**PRELIMINARY DRAINAGE REPORT AND MDDP ADDENDUM
FOR
HOMESTEAD NORTH AT STERLING RANCH PRELIMINARY PLAN**

Engineering Review

**PCD-ENGINEERING REVIEW COMMENTS
IN BLUE BOXES WITH BLUE TEXT**

PCD Filing No.:
SP-20-008

DRAINAGE MAP
HOMESTEAD NORTH
JOB NO. 25188.00
06/25/20
SHEET 2 OF 2

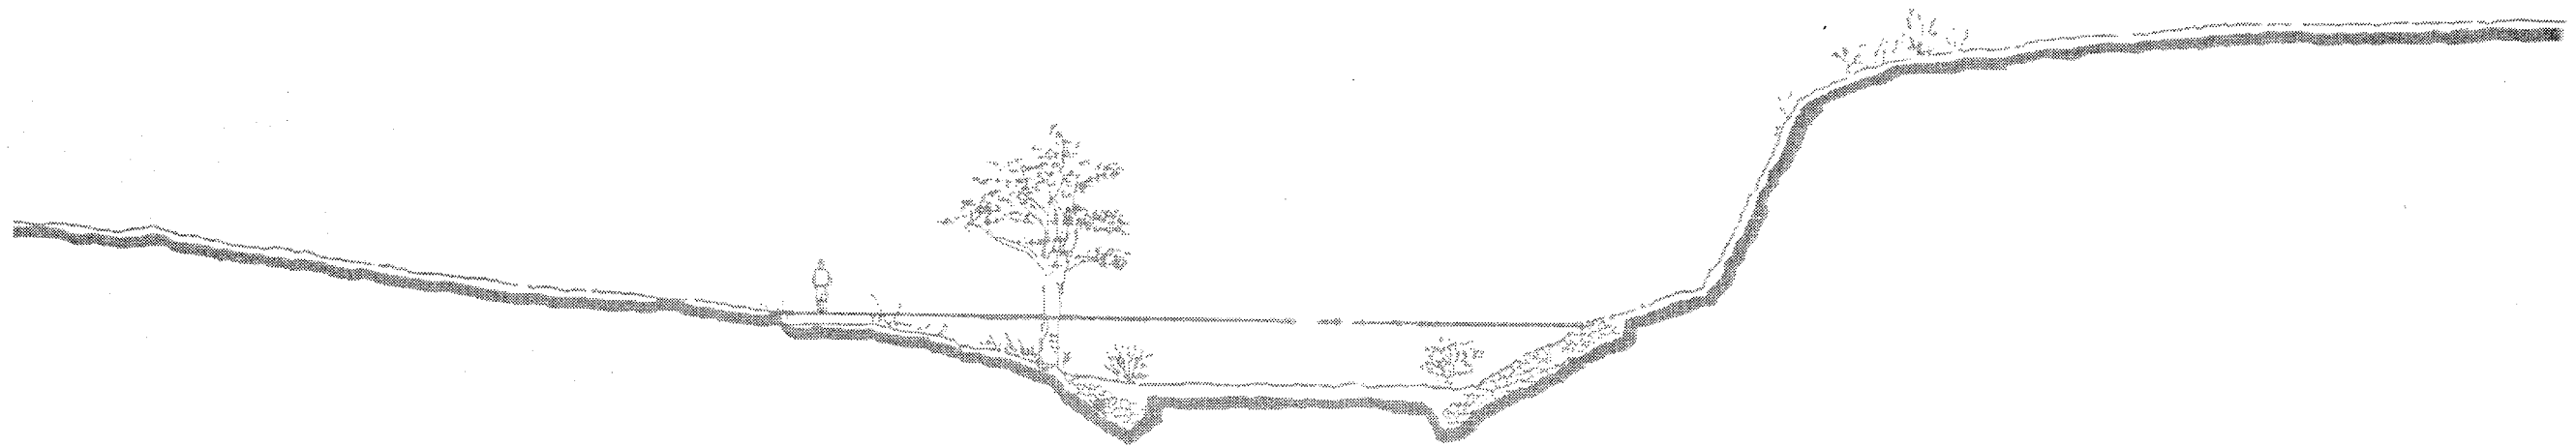
Show all proposed road and drainage improvements

Show grading for the access road/trail

Clearly show and label wetlands

show maint. access roads to ponds

Provide design point for channel

JR RESPONSE: PROPOSED ROAD AND DRAINAGE IMPROVEMENTS ARE NOW SHOWN

JR RESPONSE: GRADING HAS BEEN ADDED

JR RESPONSE: WETLANDS LABELED AND SHOWN ON PLANS

JR RESPONSE: ADDED

JR RESPONSE: DESIGN POINT ADDED
